Non-Conformance Report Rev. 5

Date Submitted: Thursday, July 23, 2015
 Job Name/No.: Castleton / #23456
 Piece Mark #'s: CT-NB2 (1)
 Production Date: 6/15/2015
 QA Inspector, Co.: R. Hamilton, KTA & B Girouard, HRV

SK-1 NOT TO SCALE

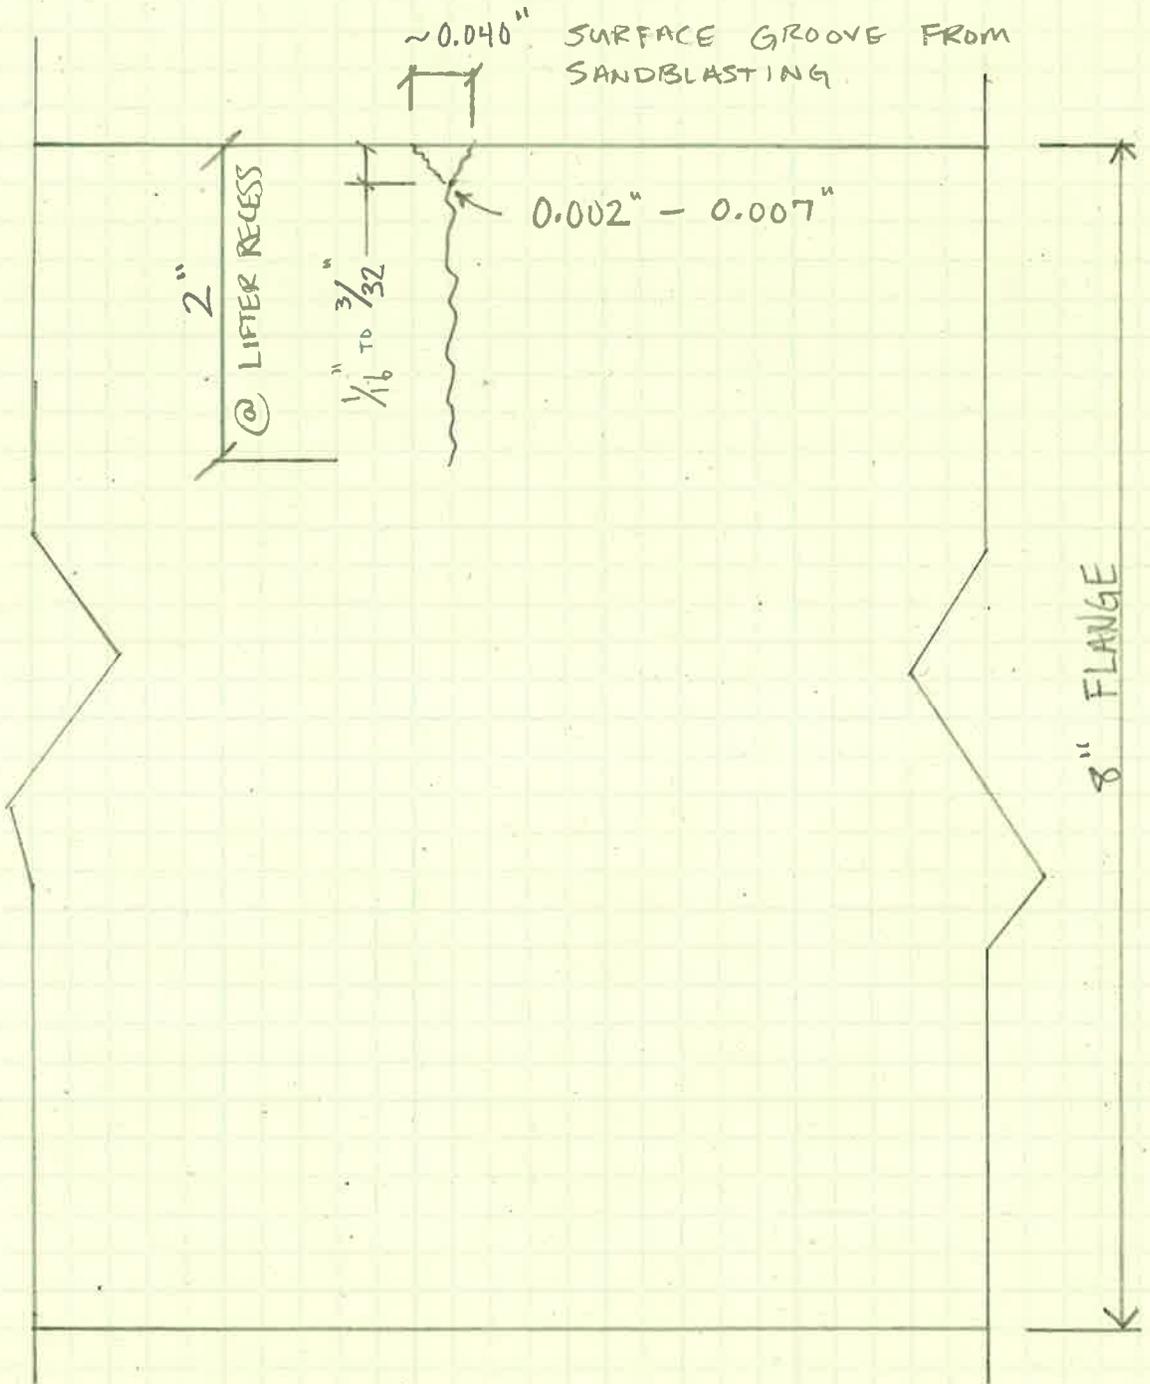
- 14 *JPC does not find any cracks in the beam having a width of 0.04". The process of sandblasting the top surface of the beam rounds the edges of the cracks making them appear wider at the top surface, refer to attached Photos & SK1. Rounded edges of the cracks extend down approximately 1/16" to 3/32". Observed crack depths at flange edges and at lifter blockouts terminate at the top mat of reinforcing. The new crack map generated 7/22/15 records the length and width of each individual crack. JPC did not observe additional cracks or increase in widths resulting from shipping and handling. All cracks in the flange generated by shrinkage or tension have occurred and have been successfully restrained by the mild reinforcement.*
